# ENDL TEXAS

Date: 18 August 2006  
To: T10 Technical Committee  
From: Ralph O. Weber  
Subject: Security Association Model for SPC-4

**Figure x1 — SA relationships**

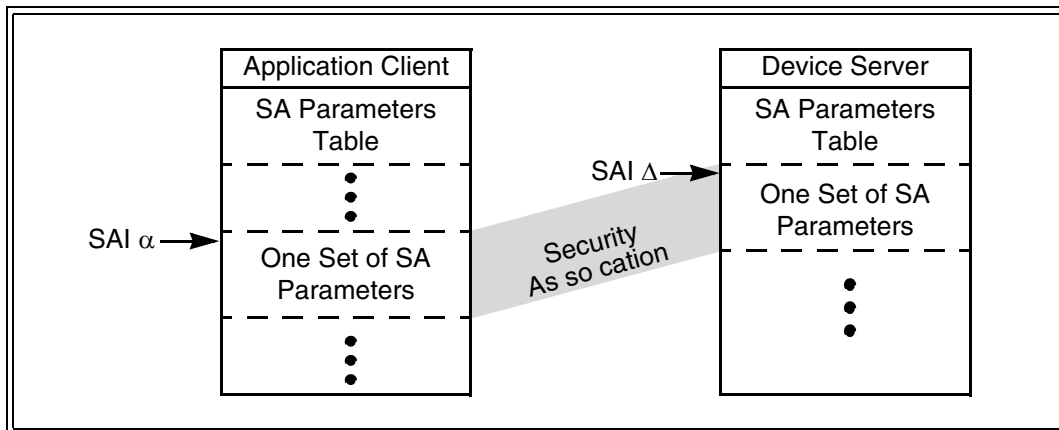
Figure x1 shows the relationship between application clients and device servers with respect to SAs.

In both the application client and the device server, the SA parameters are modelled as being stored in an indexed array and the SAI identifies one set of SA parameters within that array. The application client and device server are not required to store the parameters for any given SA in the same array locations. In order to support this implementation flexibility, a single SA is modelled as having two different SAI values (i.e., one for the application client and one for the device server).
